FORD A4LD FORD 4R44E/4R55E PREMATURE LUBRICATION FAILURE AND FRONT OIL PUMP DIFFERENCES

COMPLAINT: Premature transmission failure due to lack of lubrication and/or no cooler flow until the converter clutch is applied.

Figure 1

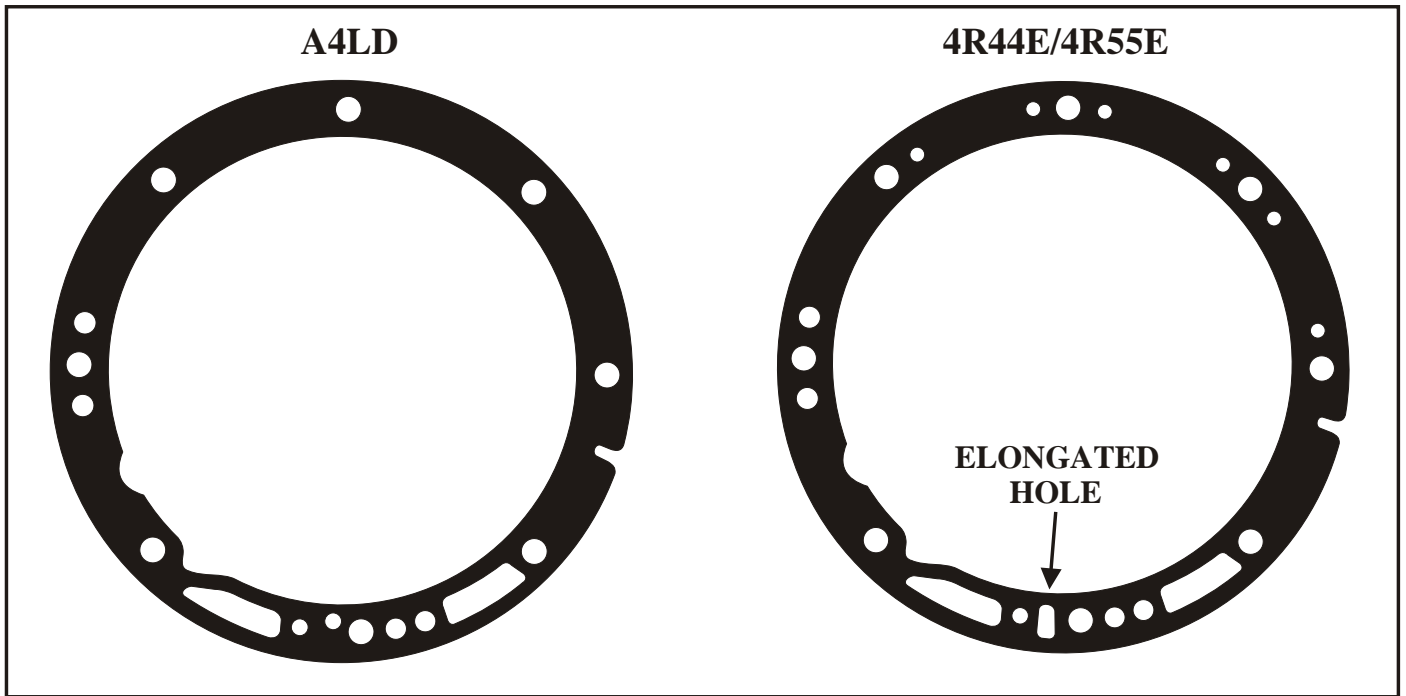
- (1) PUMP GASKET - An elongated hole was added to the 4R44E/4R55E pump gasket to accommodate changes in the related parts, for increased rear case lubrication. Refer to Figure 1.

Figure 2

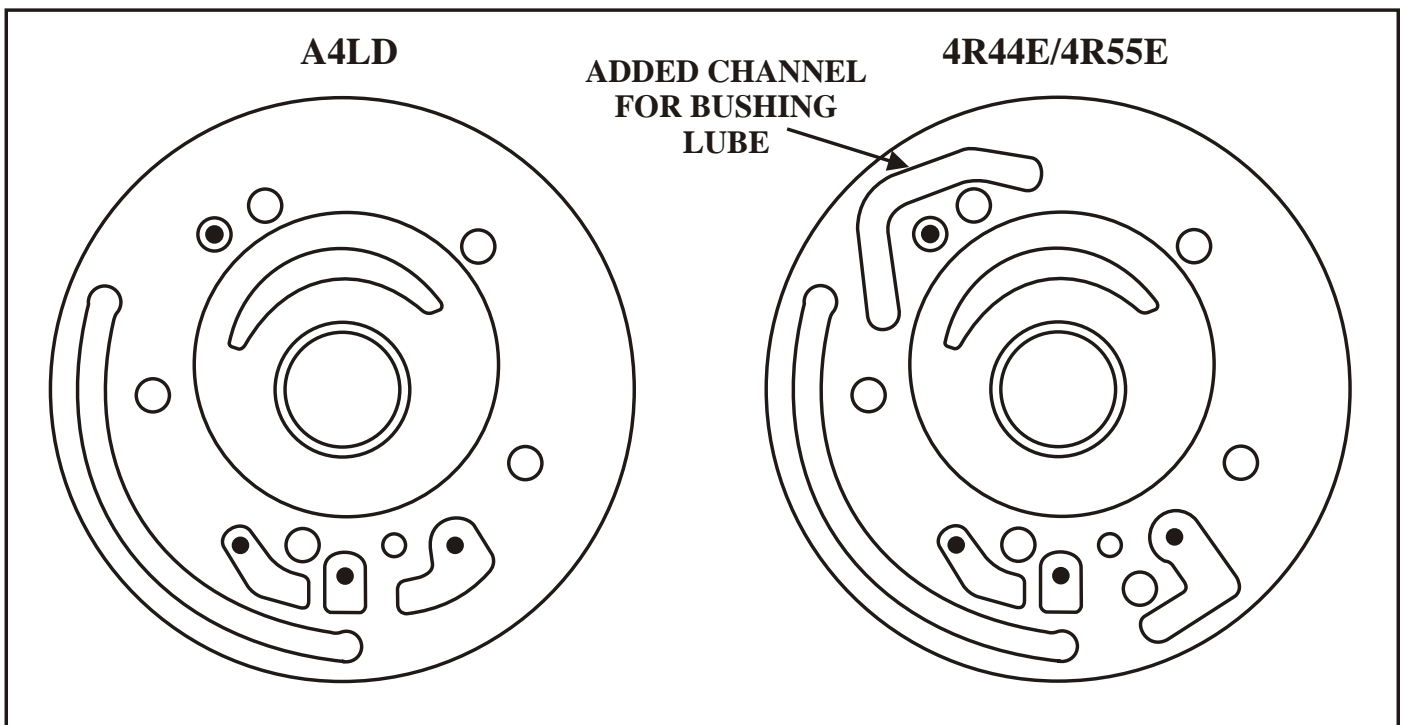
- (2) PUMP BODY - Added channel in the 4R44E/4R55E pump body for improved converter hub bushing lubrication, and a new bolt hole to accommodate an added bolt for increased clamping. Refer to Figure 2.

Figure 3

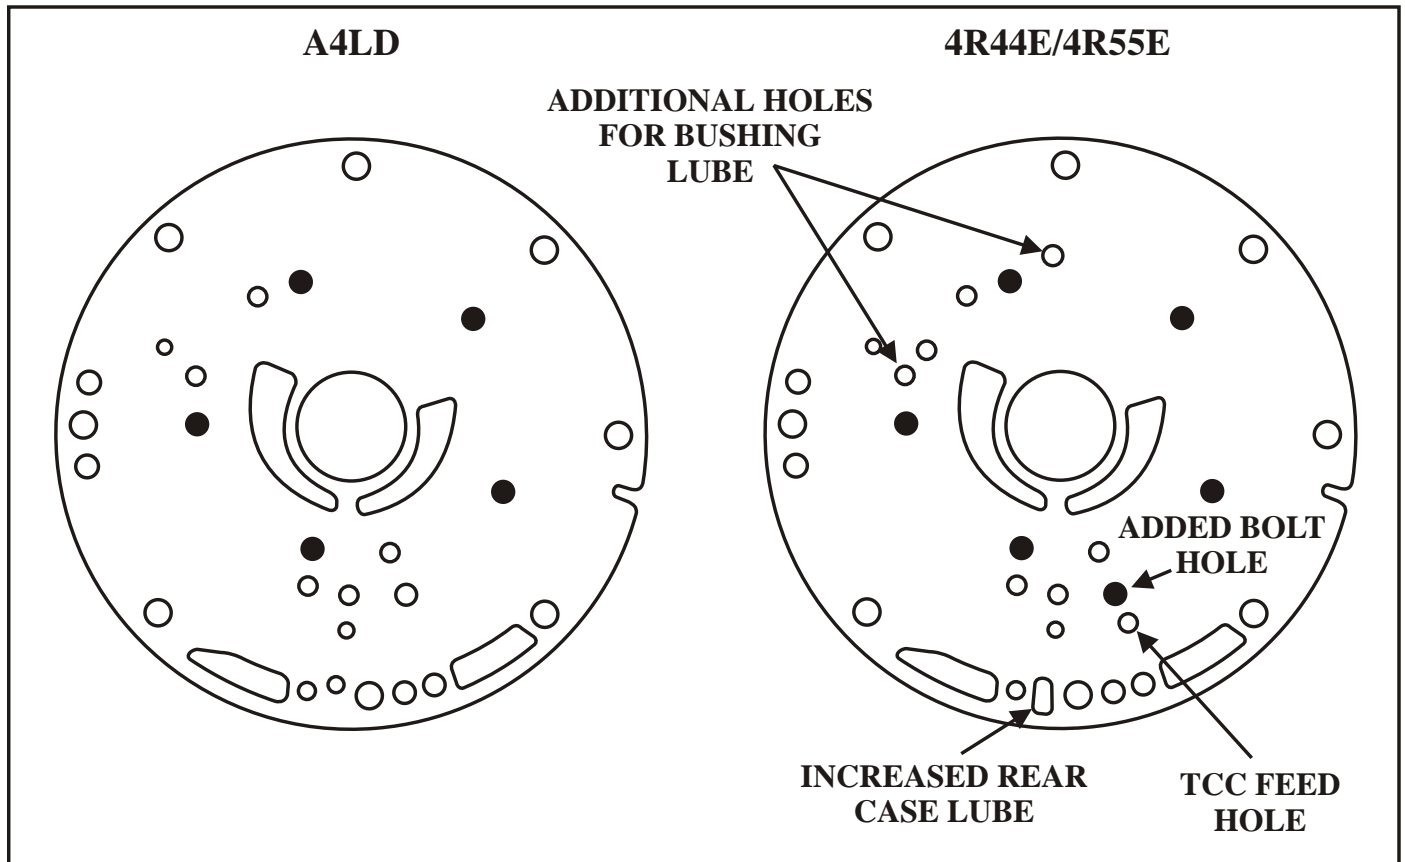
- (3) PUMP PLATE - The 4R44E/4R55E pump plate has two additional holes to accommodate the added channel in the pump body, an added bolt hole for the added bolt, an elongated lube hole, and the TCC feed passage was relocated. Refer to Figure 3.

Figure 4

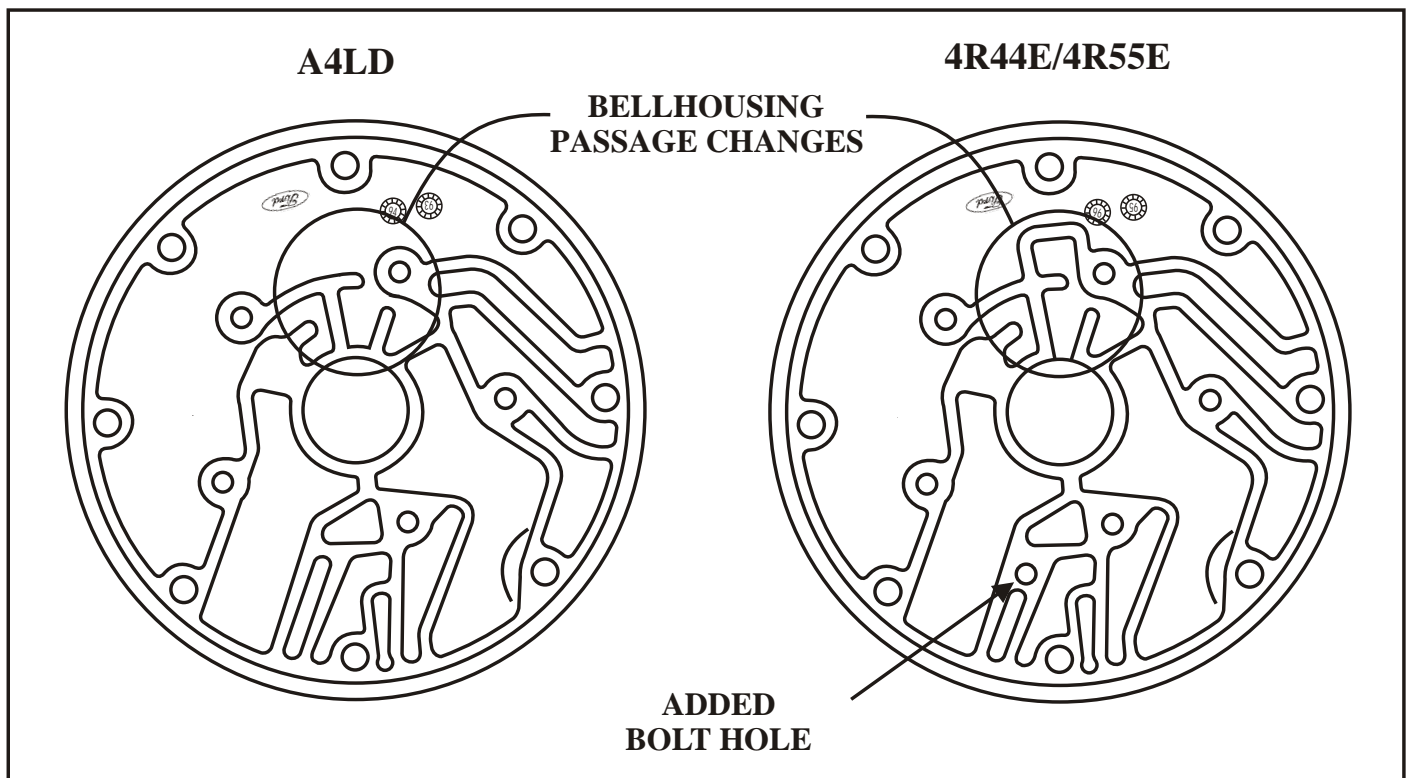
- (4) BELLHOUSING - The 4R44E/4R55E bellhousing has an added passage to accommodate the pump body changes for increased lubrication to the converter hub bushing, as shown in Figure 4.

Figure 5

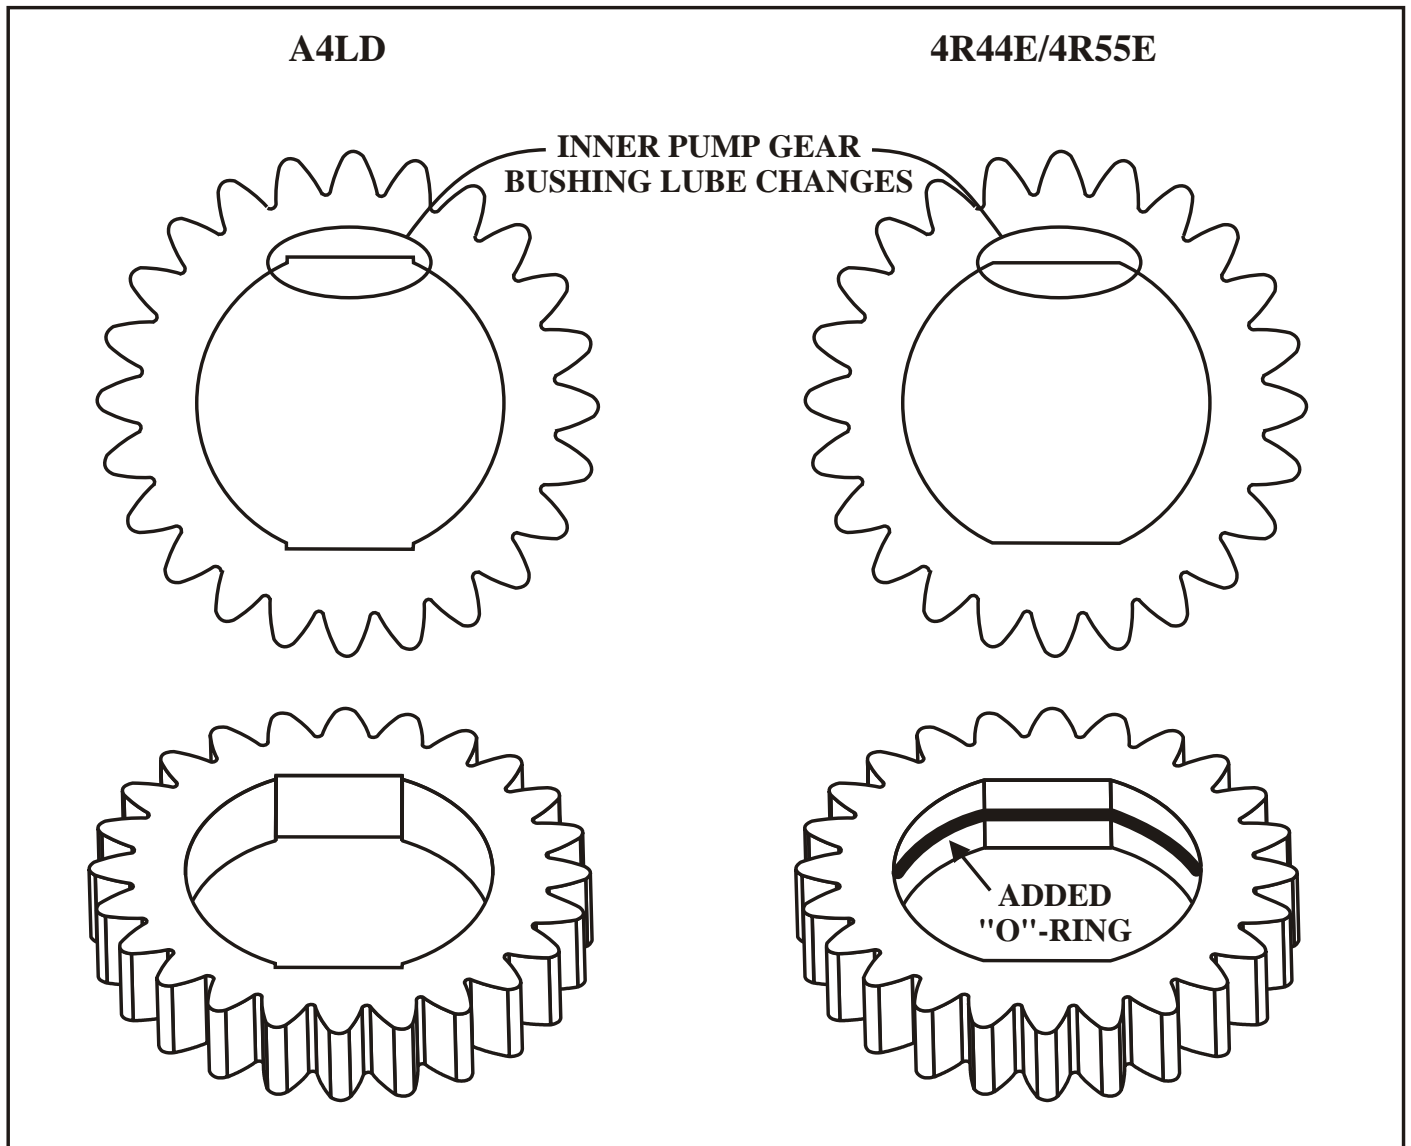
- (5) INNER PUMP GEAR - The 4R44E/4R55E inner pump gear has an easily missed change to the inside diameter and an "O" ring added in a new groove on the inside diameter to accommodate the re-routing of converter hub bushing lubrication, as shown in Figure 5.
